**City of Fairhope
Planning Commission Agenda
5:00 PM
Council Chambers
January 6, 2025**

UR 25.01 Request of AT&T for an 11.52.11 Utility Review and approval of the proposed installation of approximately 4,573 LF of buried fiber cable at 7549 Assunta Court.

A. SR 25.01 Request of the Applicant, Erik Haeffs, on behalf of the Owner, FST and Encounter Development LLC, for Site Plan Approval of Waffle House. The property is approximately 1.05 acres and is zoned B-2 – General Business District. The property is located on the northeast corner of State Highway 181 and State Highway 104, Lot #10. **PPIN #: 627500**

SR 25.01 - Waffle House

Figure 1: Landscape Plan detail of relocation of tree.

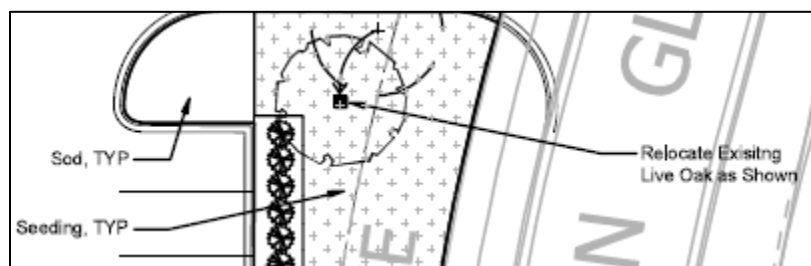
Landscaping Plan: An updated landscape plan was submitted per concerns about height of shrubs at time of planting and the shrub species was replaced with *Maki Podocarpus*. Plans include the relocation of a live oak tree that was planted by the developer as part of the Encounter development. There is concern regarding the survival of the transplanted tree amongst a working commercial development. It shall be a condition of approval that at the final inspection the City Horticulturist assess the health of the transplanted tree. If the tree is determined to be in poor health, then Applicant shall replace the tree with a healthy version of the same variety and size.

Figure 2: Landscaping Detail for Dumpster and Grease Container Enclosure.

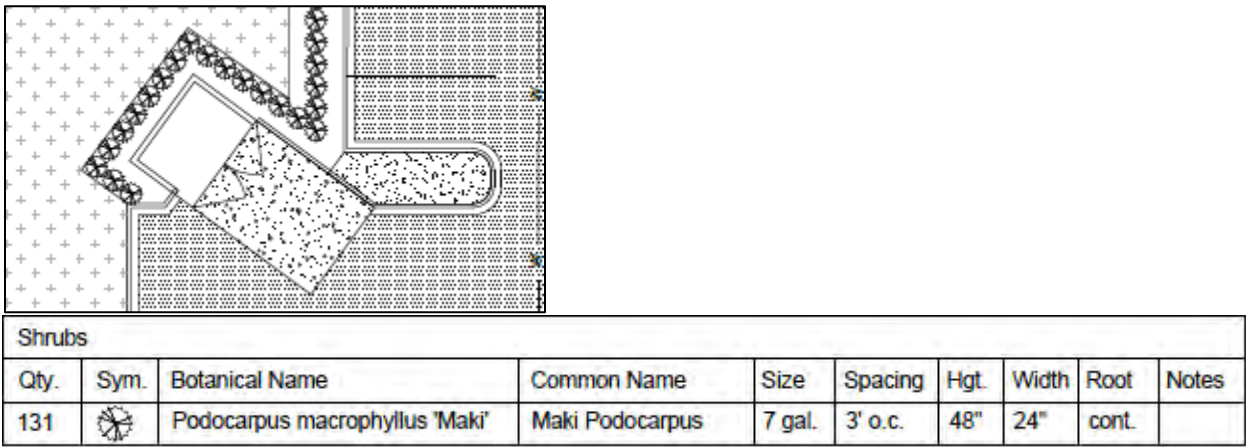
Dumpster location and screening: The dumpster enclosure is in the northwest quadrant of the site. The grease container is also within the gated enclosure. Shrubs will be around the parts of the enclosure that are not part of the vehicular use area.

SITE PLAN
SHEET
C02

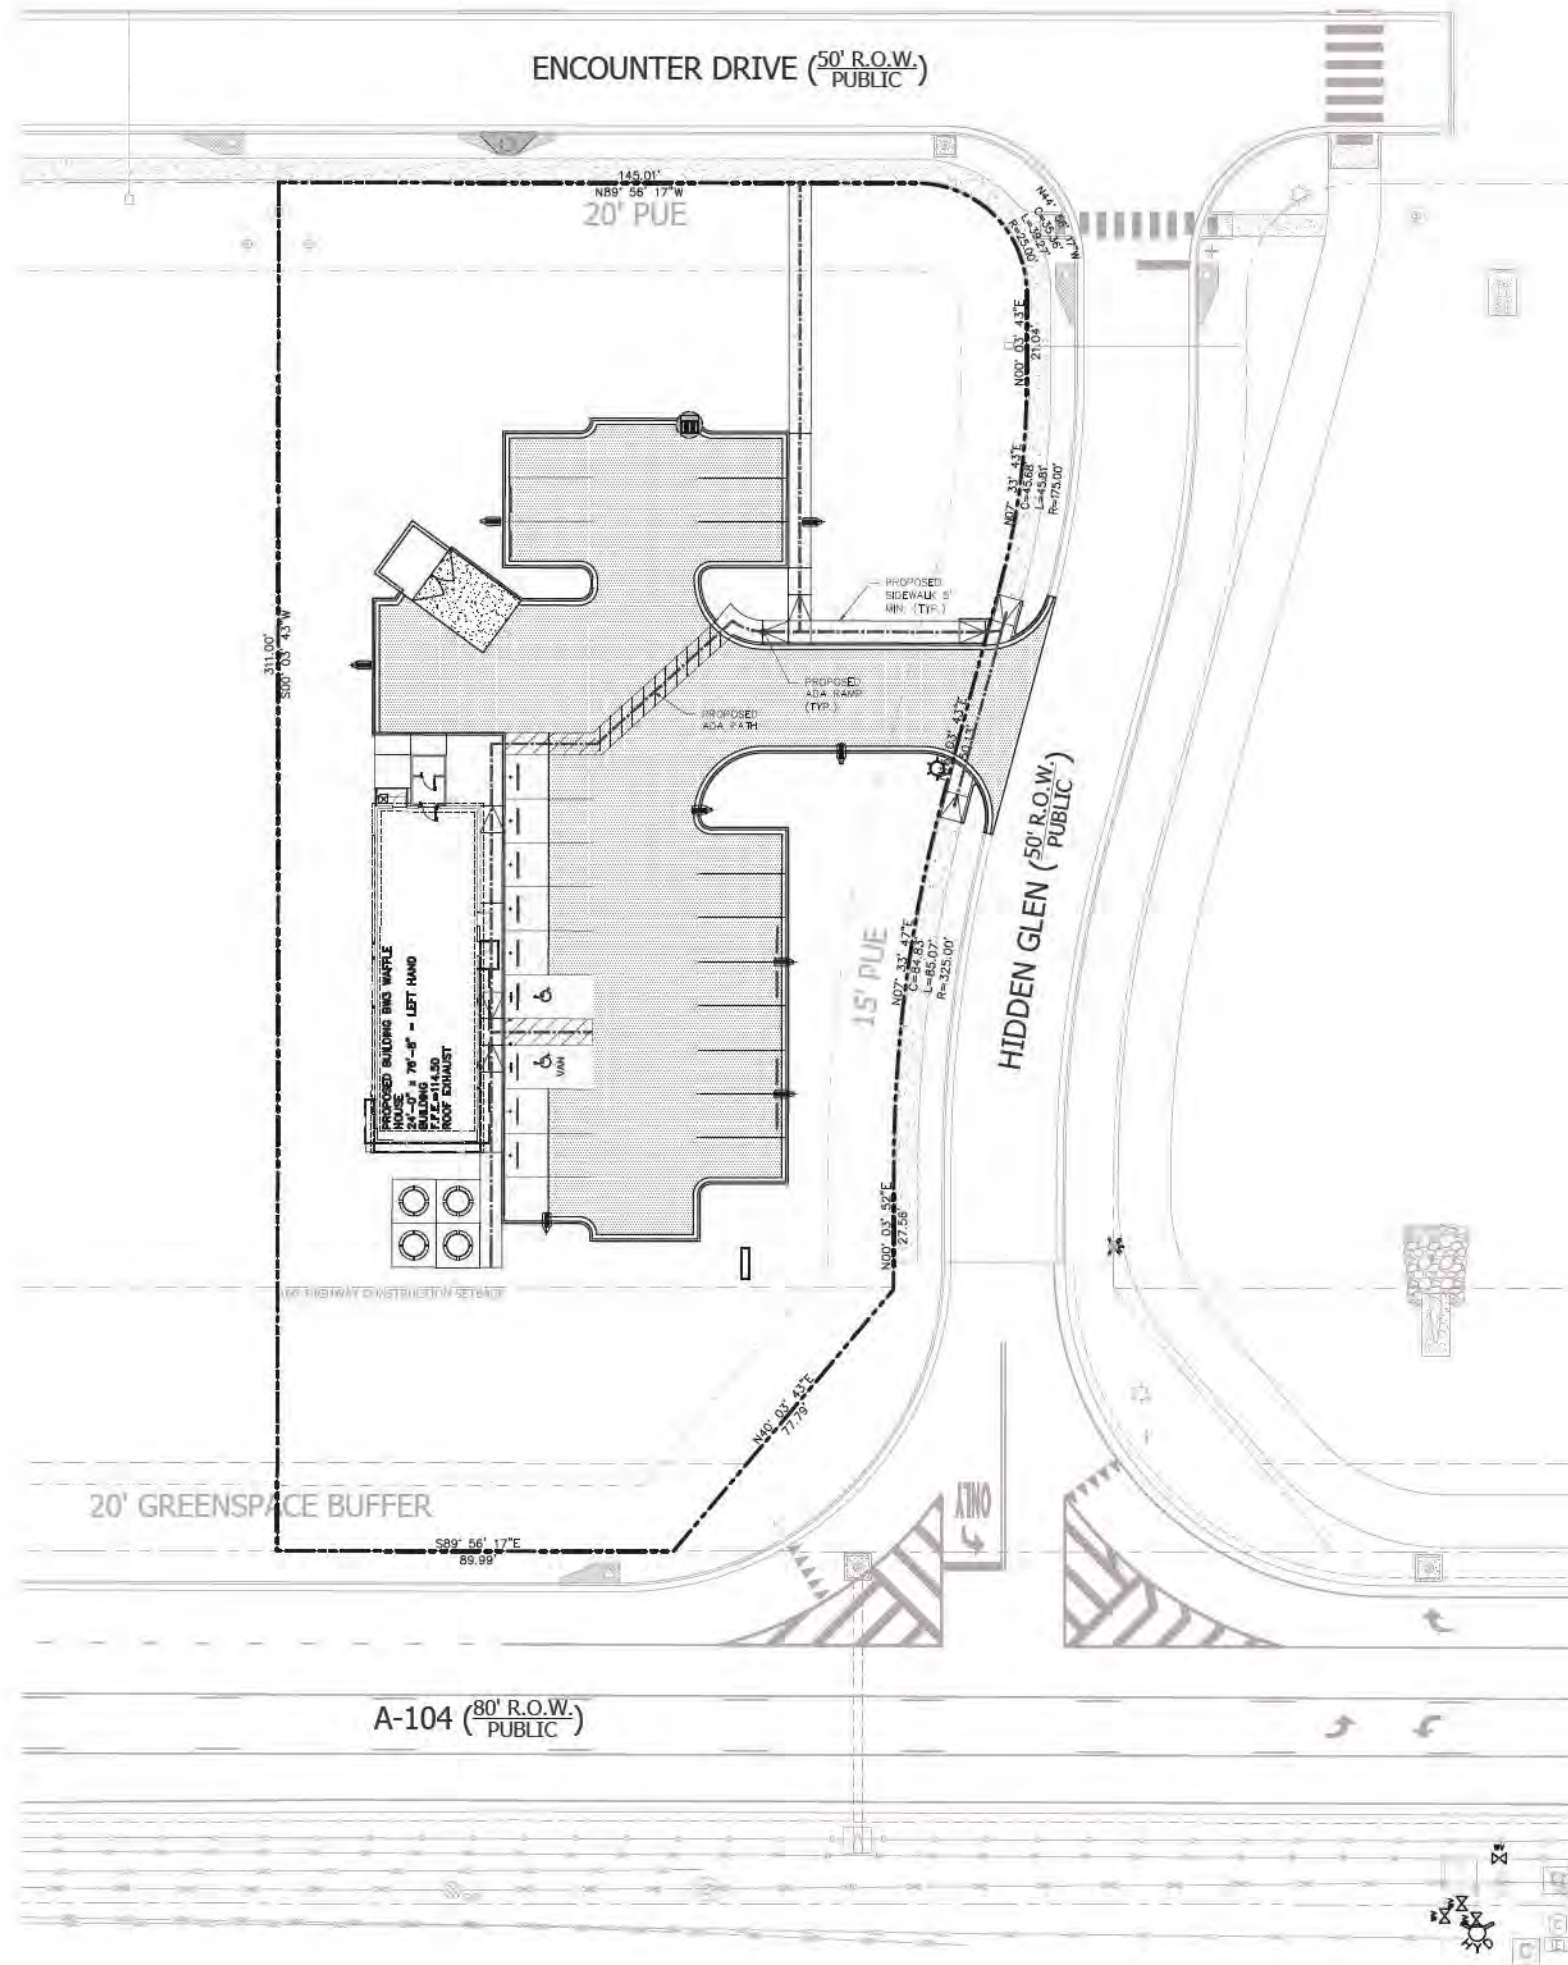
Please see revised Site Plan sheet C02 with outdoor seating next to the patio area.

LANDSCAPE PLAN

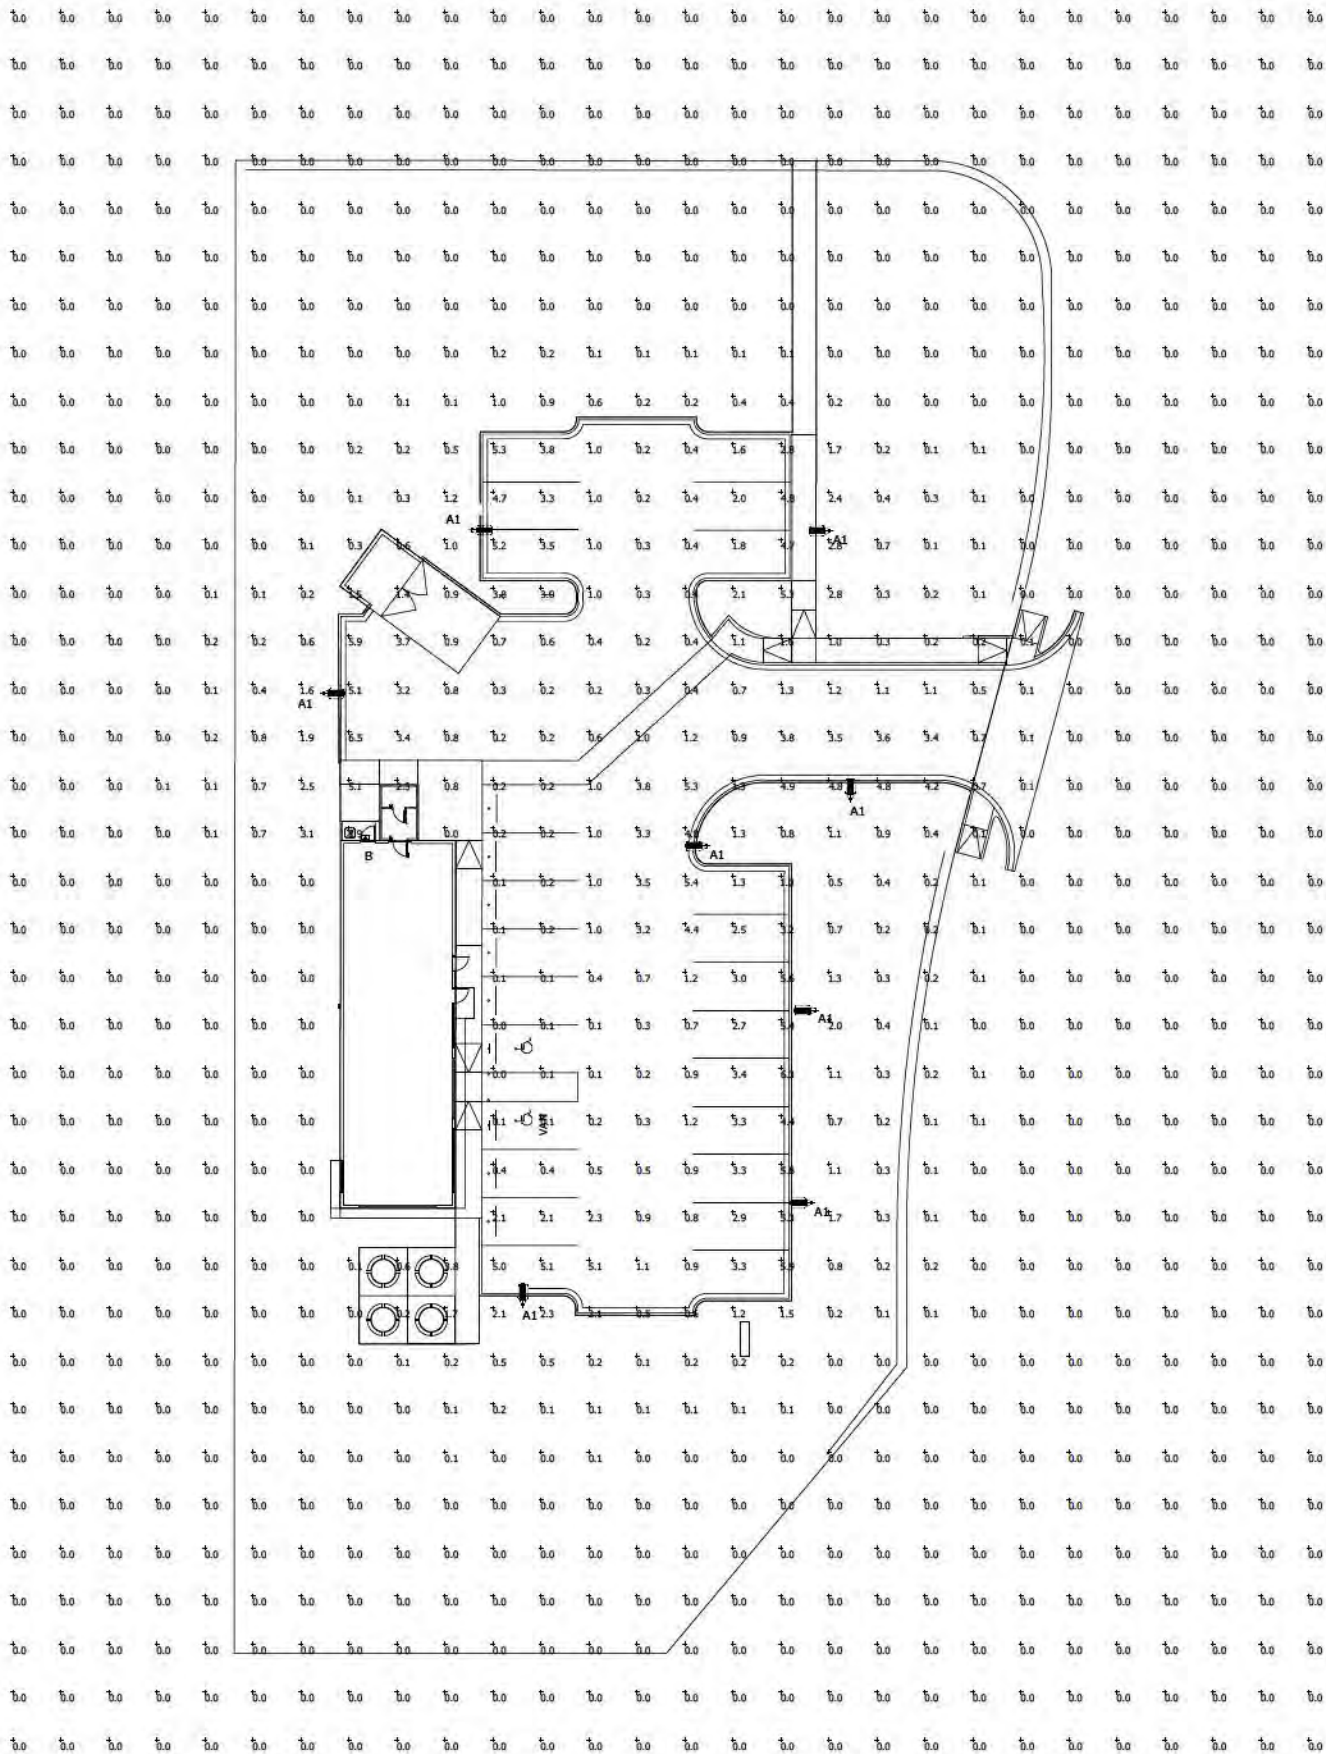
8. Make the suggested landscaping changes per the December 9 email and your acknowledgement of the same.

Please see that updated Landscape Plan addressing the December 9th comments.

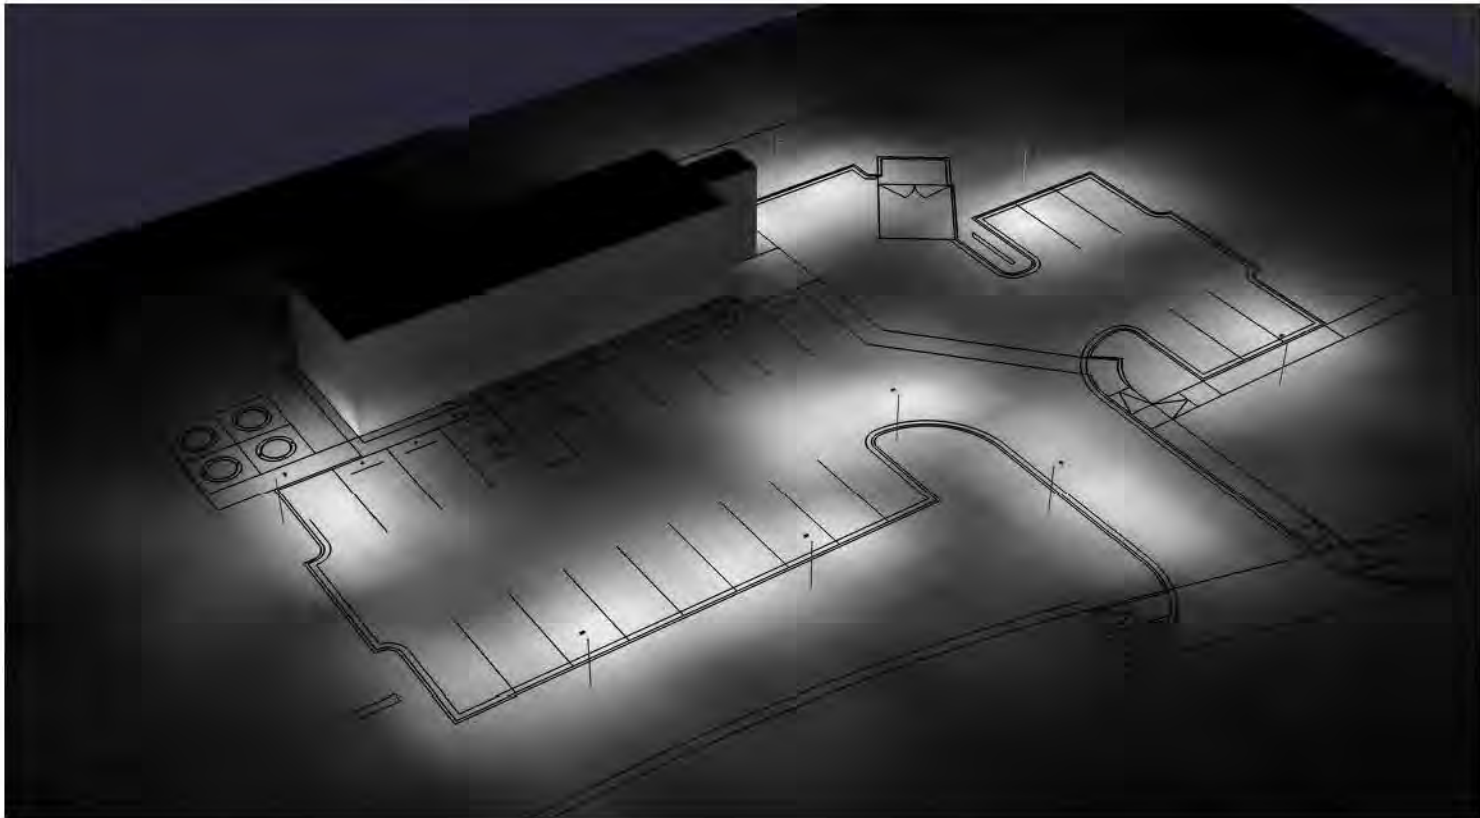
Locations, intensity, and heights of exterior lights: A photometric plan was submitted within the Complete Plans. The first draft had light poles that were too high at 23ft; whereas parking lots with 50 or fewer spaces shall have light poles that do not exceed 10ft overall height pursuant to Article IV, Section B(3) of the Zoning Ordinance. Applicant has adjusted the height to conform to the Ordinance.
